EPC STORMWATER REVIEW COMMENTS
IN ORANGE BOXES WITH BLACK TEXT

CANYON CREEK DEVELOPMENT

GRADING AND EROSION CONTROL PLANS

CANYON CREEK DEVELOPMENT	
COVER SHEET	
SHEET	1 OF 7
JOB NO.	25322.00

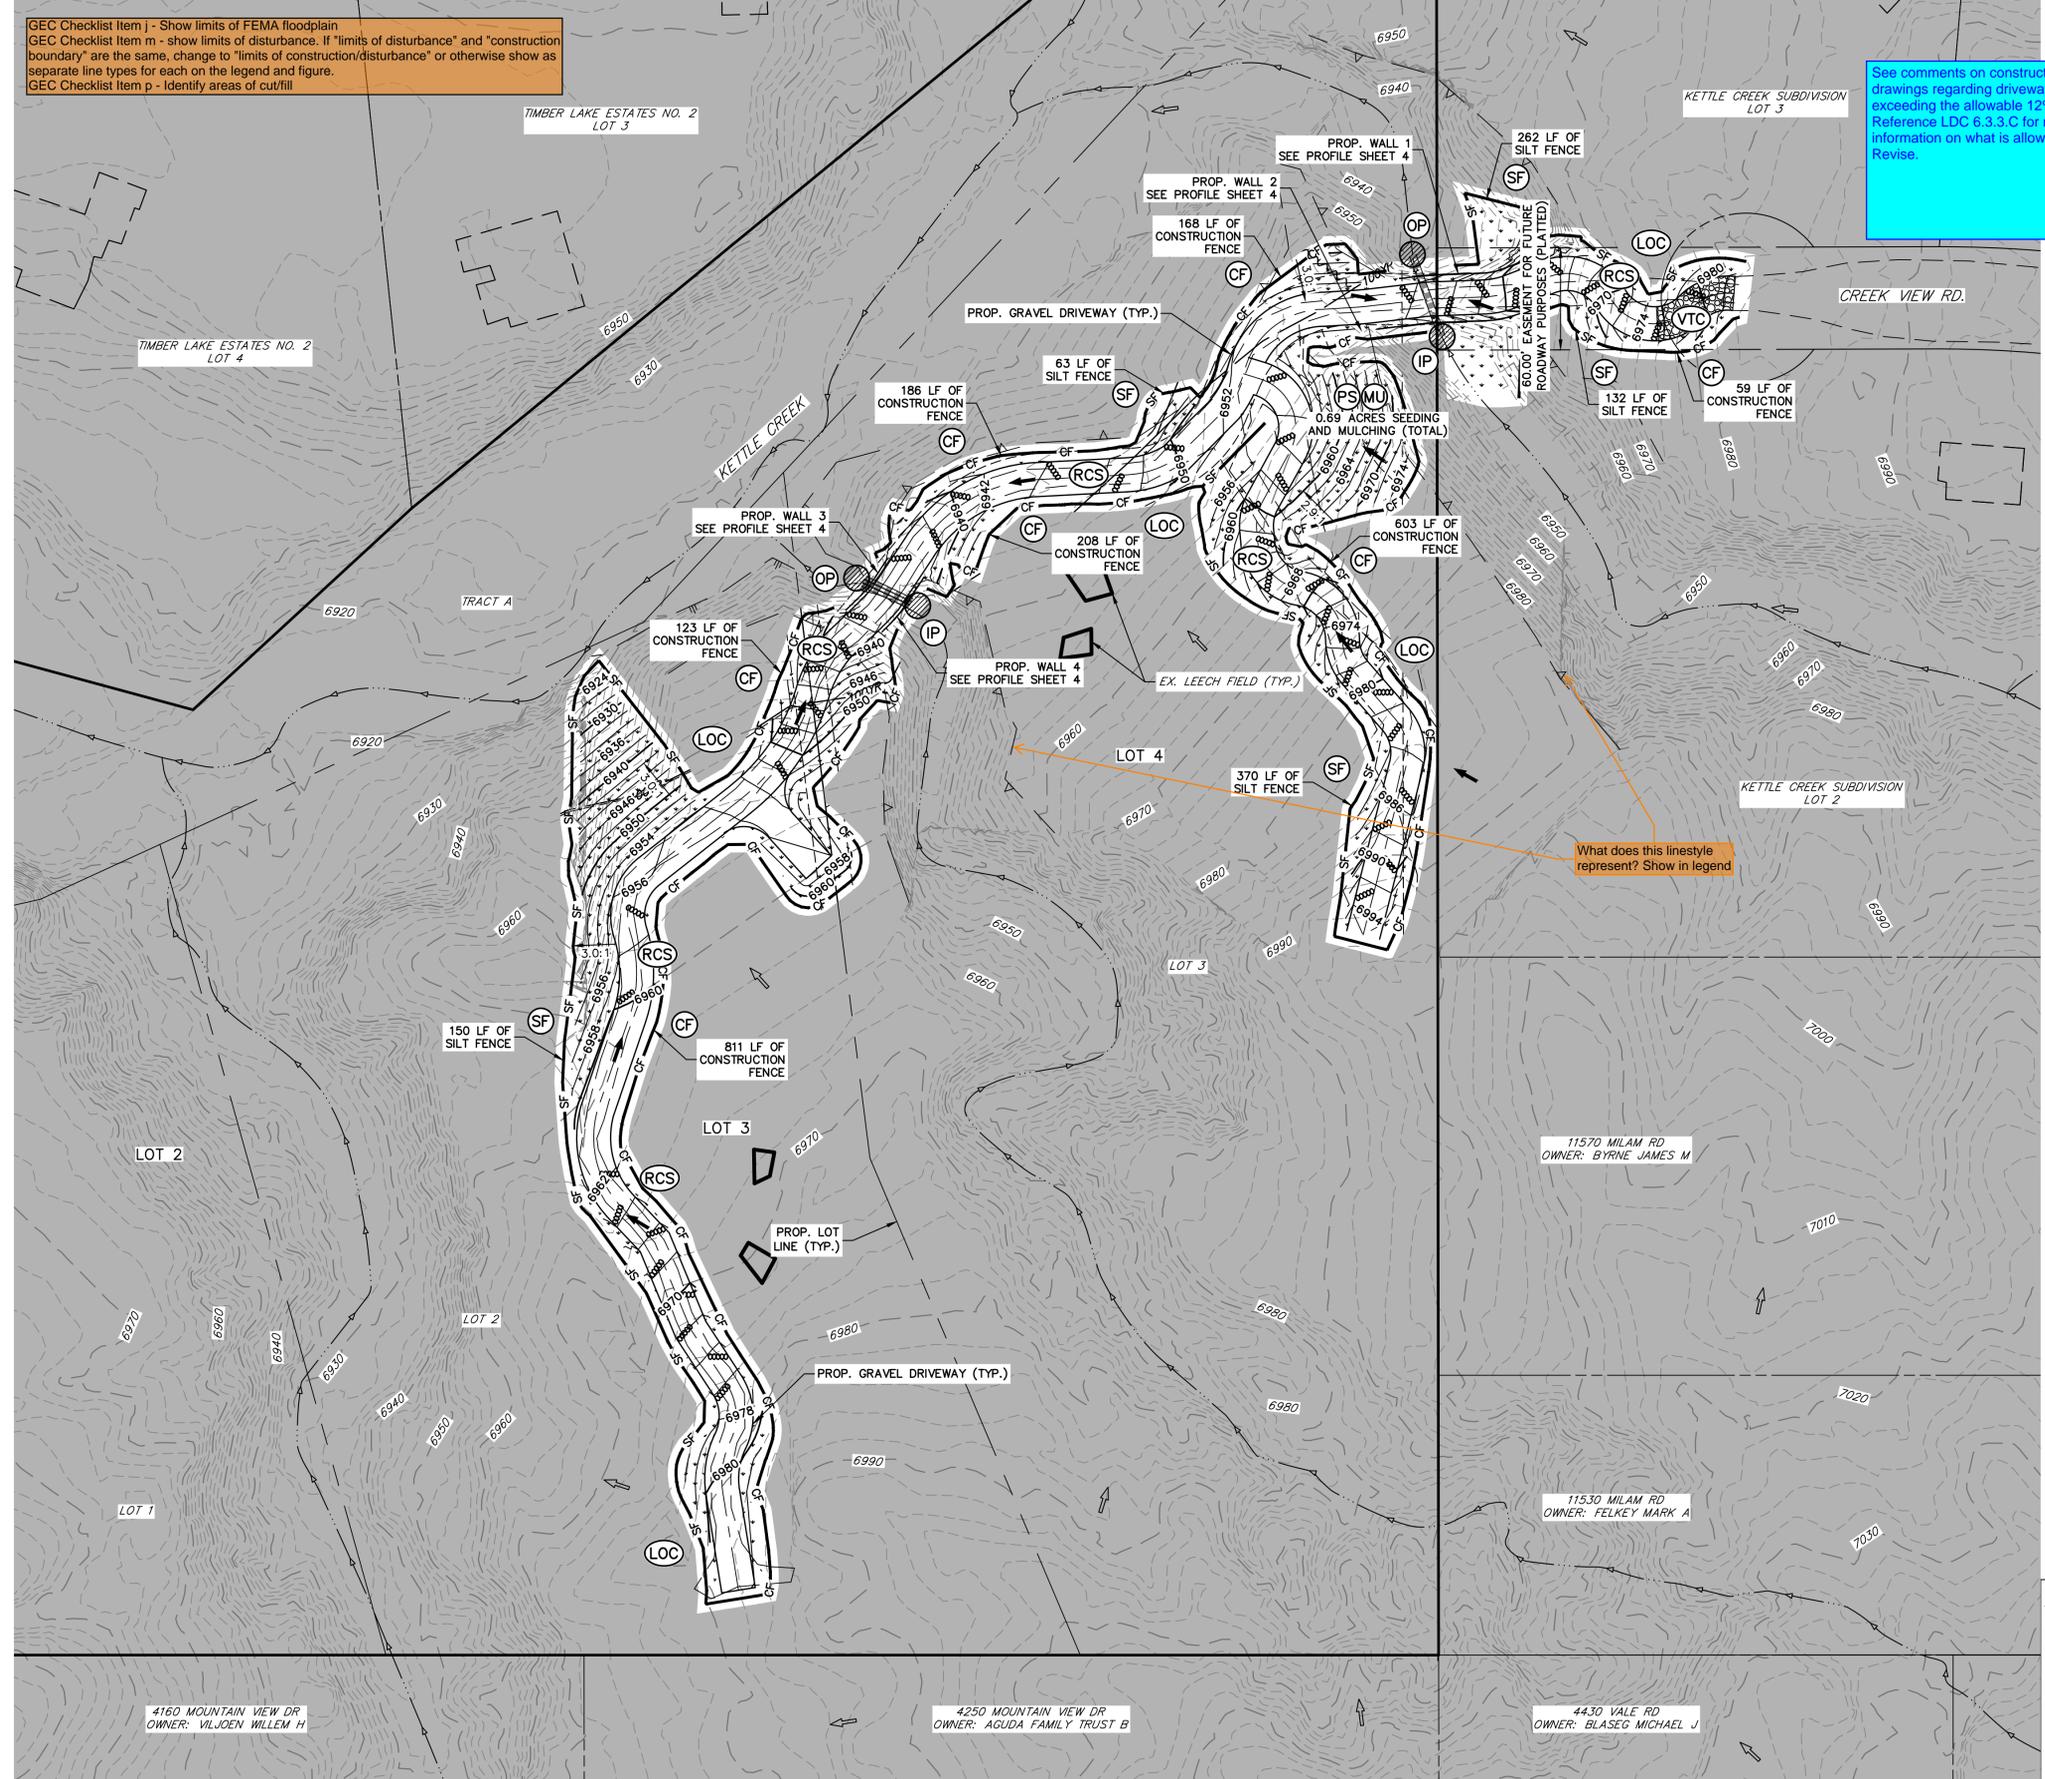
GEC Checklist Item j - Show limits of FEMA floodplain
 GEC Checklist Item m - show limits of disturbance. If "limits of disturbance" and "construction boundary" are the same, change to "limits of construction/disturbance" or otherwise show as separate line types for each on the legend and figure.
 GEC Checklist Item p - Identify areas of cut/fill

See comments on construction drawings regarding driveway grade exceeding the allowable 12%. Reference LDC 6.3.3.C for more information on what is allowed. Revise.
